ADDENDUM TO THE FINAL
CEQA ENVIRONMENTAL IMPACT REPORT
SANTA ANA RIVER CONSERVATION AND CONJUNCTIVE USE
PROGRAM JOINT PROJECTS
RIVERSIDE COUNTY, CALIFORNIA

State Clearinghouse # 2016101079

WESTERN MUNICIPAL WATER DISTRICT
14205 Meridian Parkway
Riverside, CA 92518

September 2024

The figure below is from the FEIR showing the original layout of the two alternatives analyzed in the FEIR.

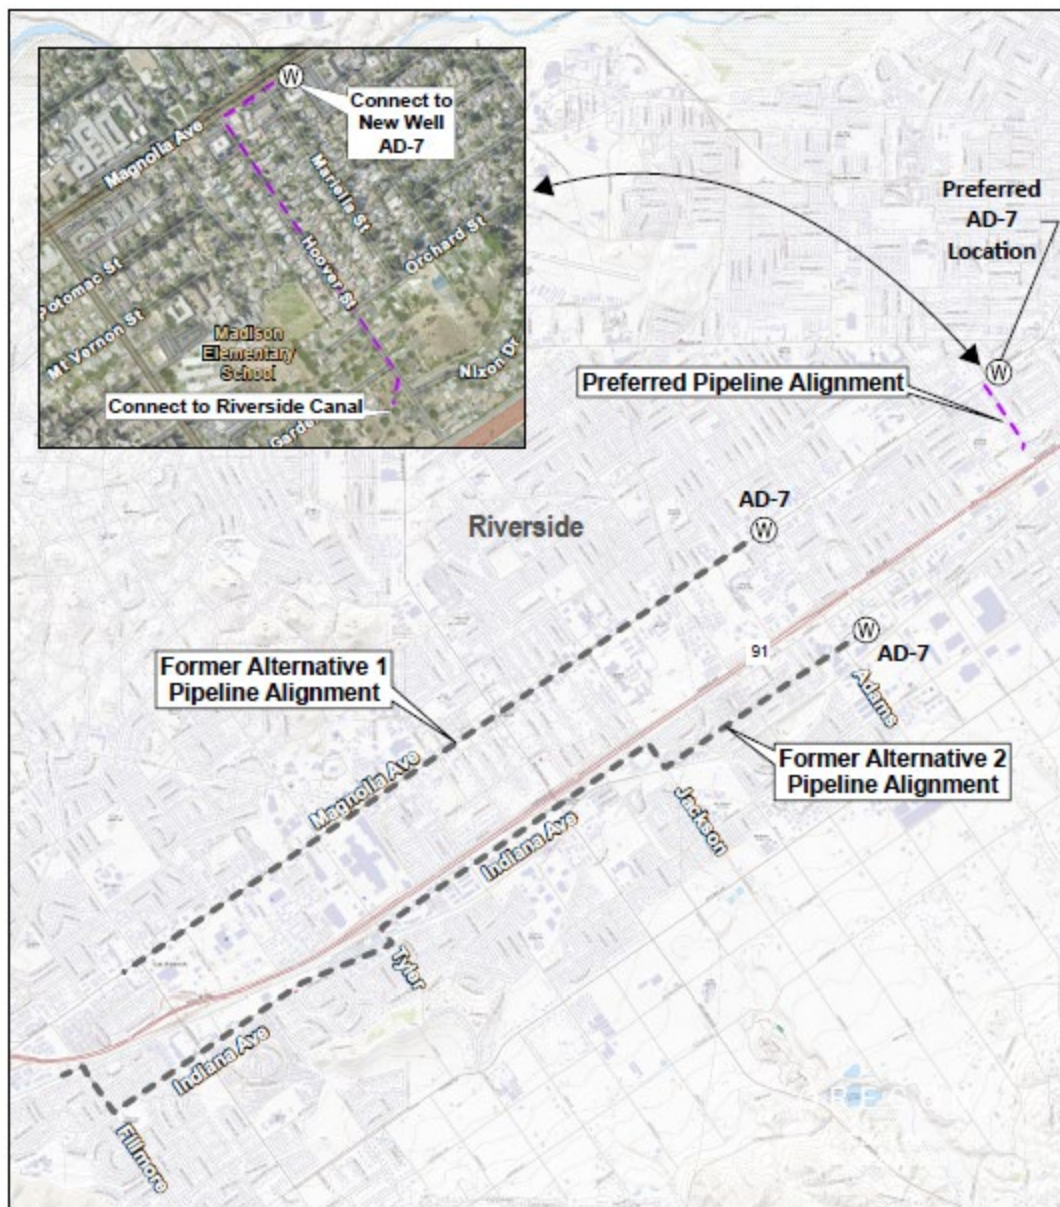
There are two minor changes proposed for the Well 7 project. The minor alterations are intended to minimize community impacts and maximize performance effectiveness of the new

First, the location of the well and pump station would be moved approximately 1.4 miles to the northeast along Magnolia Avenue. The former well site was at the CVS Pharmacy located at 8280 Magnolia Avenue. The new site is on an unused portion of the parking lot at the Magnolia Presbyterian church located at 7200 Magnolia Avenue. Figure 1 shows the new site location in relation to the FEIR's version. The new site was selected using improved ground water basin subterranean information.

Second, the alignment and length of the pipeline would change. As analyzed in the FEIR, a 4-mile pipeline constructed in public streets would extend from Well AD-7 to the southwest where it would connect directly into other non-potable supply pipelines for WMWD's Arlington Desalter facility. As modified, the proposed pipeline would be much shorter – approximately 0.48 miles in length. It would run underground in the rights-of-way of Magnolia Avenue for a short distance and then in lightly used Hoover Street for the remainder of the distance and discharge directly into the existing Riverside Canal (see Figure 2). The discharged flows will be conveyed by gravity (not pumped) through the existing Riverside Canal to WMWD's existing non-potable water system. Flows will be collected from the canal by WMWD's existing Jefferson Street Pump Station, conveyed into WMWD's existing non-potable water system to supplement less abundant recycled water in lieu of imported Colorado River water for direct distribution to retail water users in WMWD's Riverside service area. Additionally, portions of the groundwater received through the existing canal and non-potable system, based on seasonal availability, would be conveyed through existing infrastructure to WMWD's existing recharge basins making them available for extraction at the Arlington Desalter facilities.
